## City of Lone Tree Planning Commission Agenda Tuesday, July 14, 2015

**RidgeGate Section 15, Filing 17, 1<sup>st</sup> Amendment, Lot 6A**  
**Site Improvement Plan #SP15-29R**

**SUBJECT:** RidgeGate Sec. 15, Flg. 17, 1<sup>st</sup> Amdt, Lot 6A  
Site Improvement Plan (RidgeGate III)  
Project SP15-29R

## RIDGEGATE PLANNED DEVELOPMENT, PLANNING AREA C/M-U 2 SITE IMPROVEMENT PLAN #SP15-29R

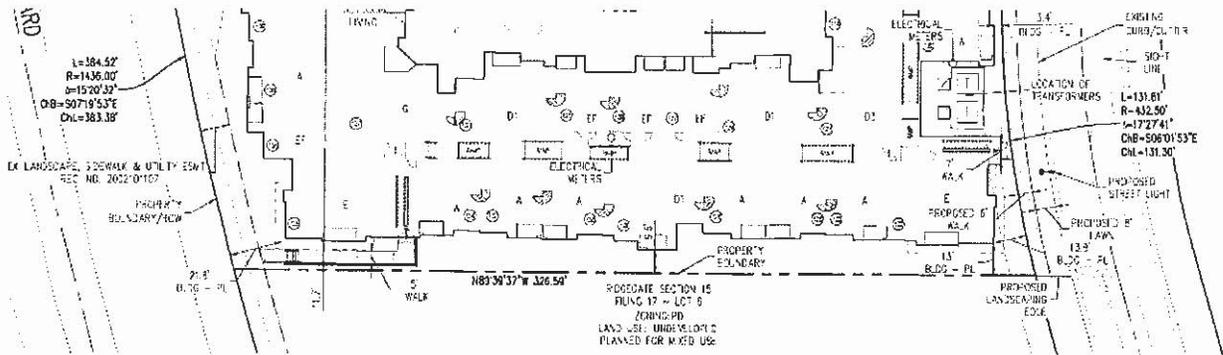
Please provide a brief code analysis on how you meet the fire separation distance requirements for the South side of the building as shown above.

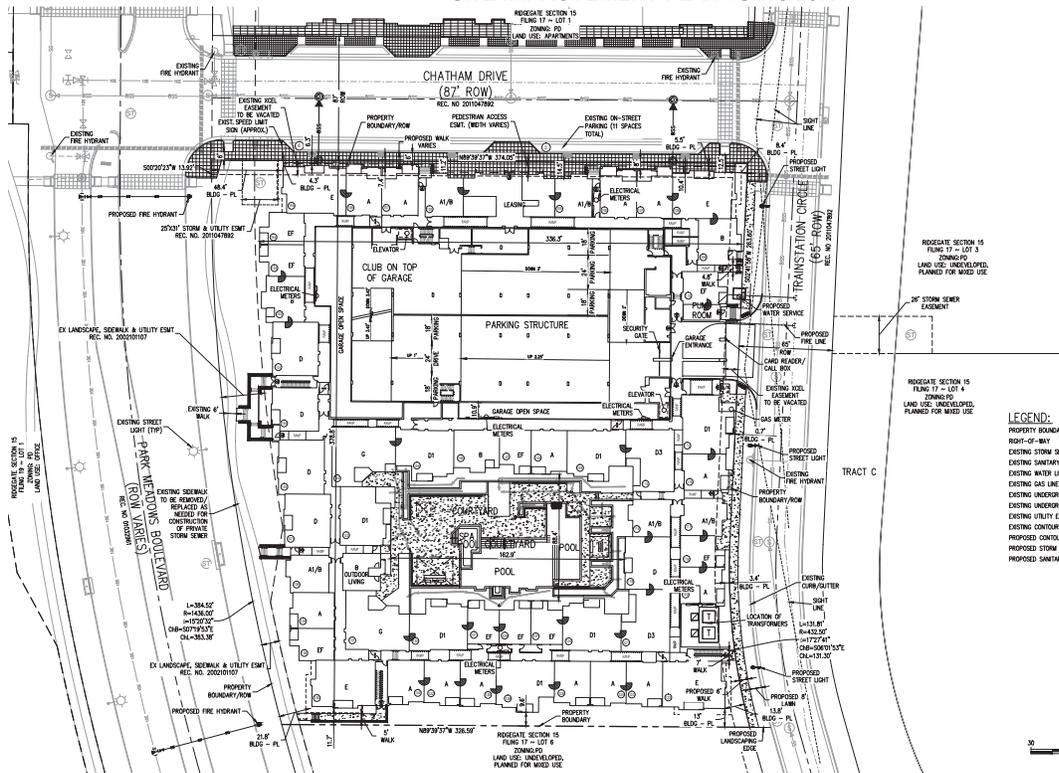
- a. The Project is proposing installation of non-standard hardscape (e.g. other than plain sidewalk) within the Chatham Drive ROW. The City of Lone Tree will not maintain this hardscape and tree wells/landscaping. Accordingly, either the Rampart Range Metro District or the proposed development must accept responsibility for maintenance of these improvements. For the similar improvements at the VUE development (MFI II), the RRMD accepted this responsibility. Anticipating the same arrangement for MFI III, the following note should be added to the cover sheet:

Either by letter, or, more preferably by an RRMD signed approval note on the SIP Coversheet, the RRMD should provide documentation this agreement to the City.

- b. The following “Snow Removal Maintenance” Note should be added to the cover sheet:

SITE PLAN  
2 OF 22  
RIDGEGATE III

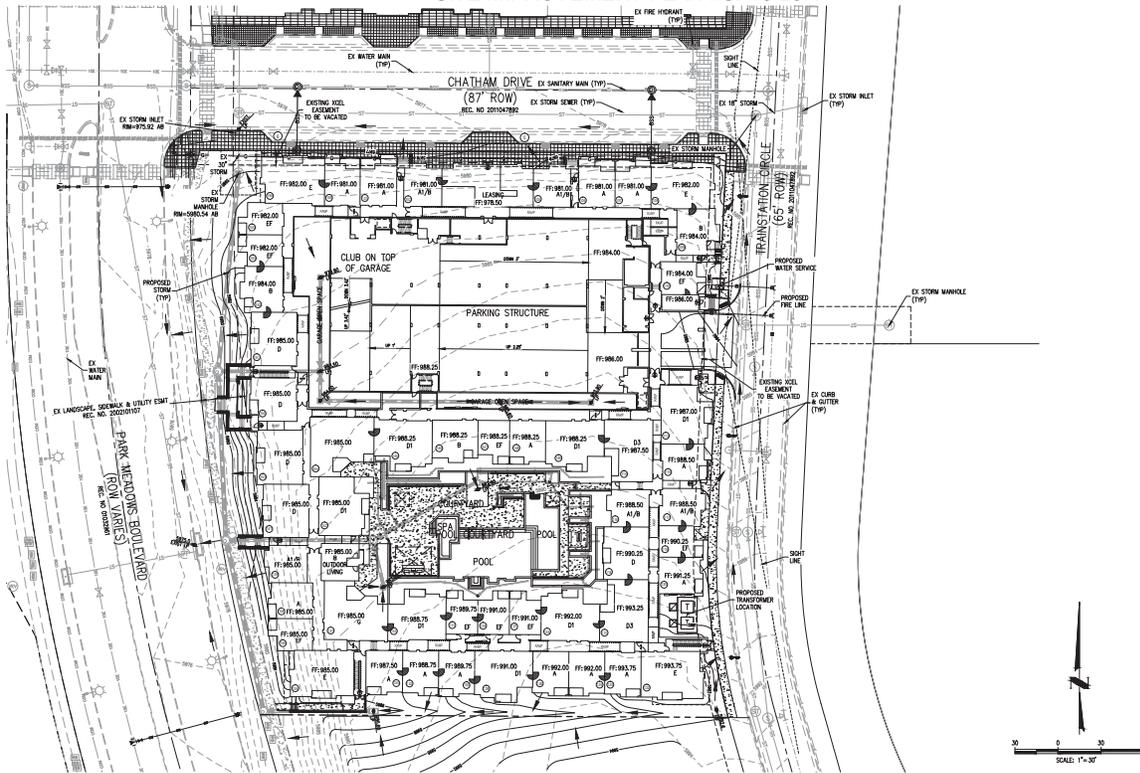
- b. Stairs/landings are shown along the west side of the building as encroaching into the existing Landscape, Sidewalk and Utility Easement along Park Meadows Boulevard (Rec. No.2002101107). This easement was granted to RRMD #1. RRMD #1 may be able to grant written and recorded permission for the indicated encroachments. Otherwise, either the easement would need to be modified and re-recorded to eliminate the encroachments or the Project design would need to be modified to eliminate the encroachments. Prior to receipt of a Building Permit

- c. Intersection/driveway sight distance lines are shown for the drive entrance off Train Station Circle. Similar sight distance lines also should be shown at the Chatham Drive/Train Station Circle intersection.
  - d. The available “clear” walkway width between the tree wells and building (along Chatham Drive) is identified for most of the proposed tree well locations. However, this dimension is not provided for the westerly most tree well, and should be added. Additionally, the similar dimension should be provided from the top (southern) edge of the sidewalk ramps and the building or back of walk (at each of the two intersections).
3. Landscape Plan (Sheet 9):
